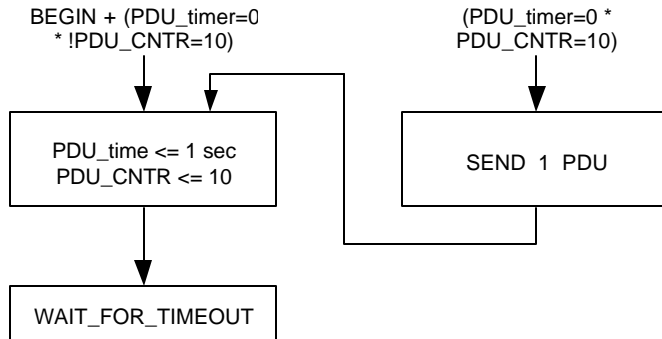
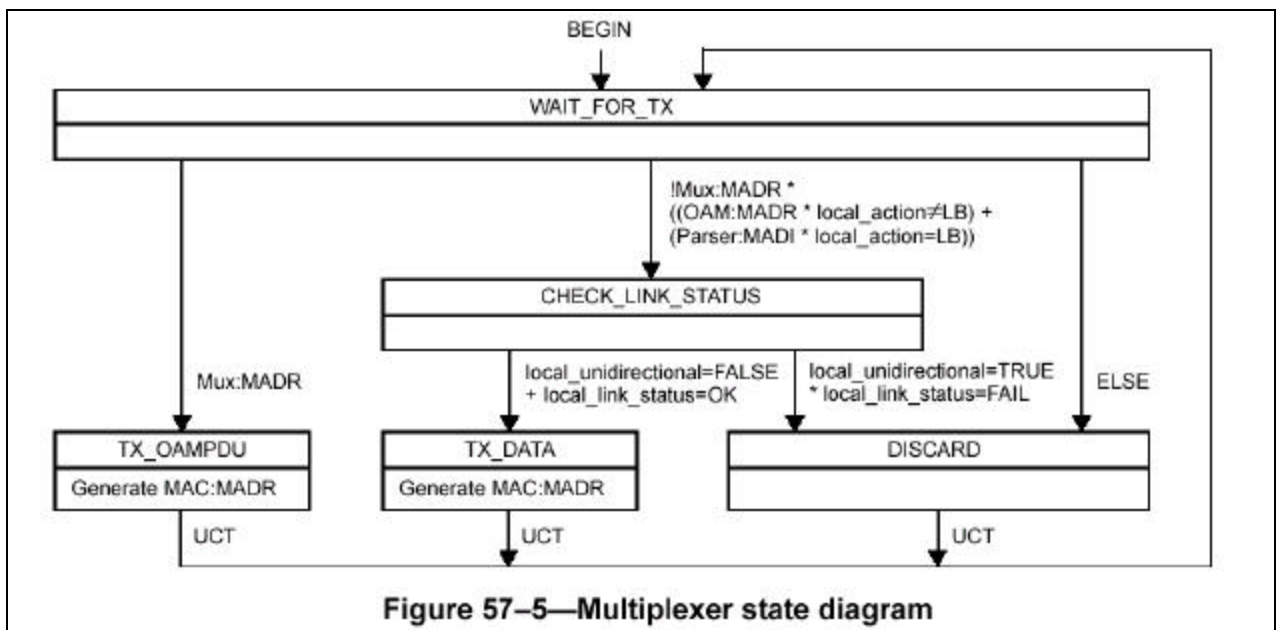
This state machine sets a count down timer to 1 second, sets a PDU counter to 10, and waits for the timer to expire. Figure 57-5 is modified to decrement the counter each time a PDU is sent within the 1-second window. If the timer expires without any decrement of the counter during that 1-second window, a PDU is sent.

Figure 57-5 is also modified to disallow PDU transmission when the PDU counter reaches zero. This affects the gates into the TX_OAMPDU and CHECK_LINK_STATUS states.

57-5 changes:

Change TX_OAMPDU gate to: Mux:MADR * !PDU_CNT=0

Change TX_OAMPDU action to: Generate MAC:MADR, PDU_CNT <= PDU_CNT-1

Change CHECK_LINK_STATUS gate to: (!Mux:MADR + PDU_CNT=0) * ((OAM:MADR...
